Notice of Intent

Type of Action: APD Change

Procedure Description: Devon Energy Production Co., L.P. (Devon) respectfully requests a change to the drilling plan for the Morgan 25-13 Fed Com 305H, 616H, 625H, 715H and 735H to include break test variance with stump testing . Attachment included.

PECOS DISTRICT DRILLING CONDITIONS OF APPROVAL

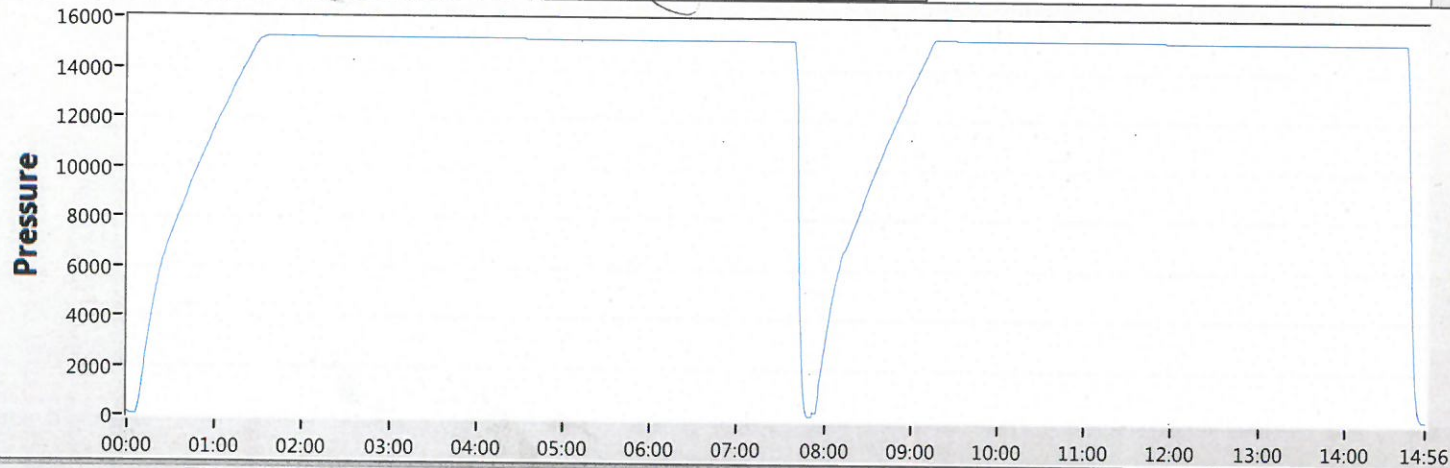
Devon Energy requests to only test BOP connection breaks after drilling out of surface casing and while skidding between wells which conforms to API Standard 53 and industry standards. The initial BOP test will follow 43 CFR 3172, and subsequent tests following a skid will only test connections that are broken. This test will at minimum include the Top Pipe Ram, HCR, Kill Line Check Valve, QDC (quick disconnect to wellhead) and BOP shell of the 10M BOPE to 5M for 10 minutes. Additional pressure testing is required for pressure-containing and pressure-controlling connections when the integrity of a pressure seal is broken. If a break to the flex hose that runs to the choke manifold is required due to repositioning from a skid, the HCR will remain open during the shell test to include that additional break. The variance only pertains to intermediate hole-sections. This variance will meet or exceed 43 CFR 3172 per the following: Devon Energy will perform a full BOP test per 43 CFR 3172 before drilling out of the intermediate casing string(s) and starting the production hole, testing the Annular during initial BOP testing to a minimum of 70% RWP and higher than MASP, and pressure testing at a 21-day interval frequency. The BLM will be contacted 4hrs prior to a BOPE test. The BLM will be notified if and when a well control event is encountered. In the event break testing is not utilized, then a full BOPE test would be conducted.

Devon Energy requests to perform offline BOP stump testing and offline BOPE testing. All pressure-containing and pressure-controlling seals will be tested either online or offline as denoted in the table below and per BLM approval during initial BOP test following test pressure requirements set forth in 43 CFR 3172. Remaining components not tested offline or on the stump will be tested within 72-hours when the BOP is connected to the wellhead. If stump testing exceeds 72-hour window prior to connecting to the wellhead, the BLM will be notified and either stump testing restarted, or the BOP being tested online. The BLM will be contacted 4hrs prior to a BOPE test. The BLM will be notified if and when a well control event is encountered. In the event stump testing is not utilized, then a full BOPE test would be conducted.

Devon requests Break testing as stated above for 5K tests, not including production hole

Annular Preventer will be tested to minimum of 70% RWP and higher than MASP during initial BOP test

Pressure testing is required for pressure-containing connections if the integrity of a pressure seal is broken during a break test

Full Tests required when entering production hole

All Previous COAs Still Apply. Variance request procedure is approved as written, please see below general conditions for variance.

- **BOPE Break Testing is ONLY permitted for 5M BOPE or less. (Annular preventer must be tested to a minimum of 100% of BOPE working pressure and shall be higher than the MASP)**

- BOPE Break Testing is NOT permitted to drilling the production hole section.
- Variance only pertains to the intermediate hole-sections and no deeper than the Bone Springs formation.

Operator has been **(Approved)** to test the BOPE offline.
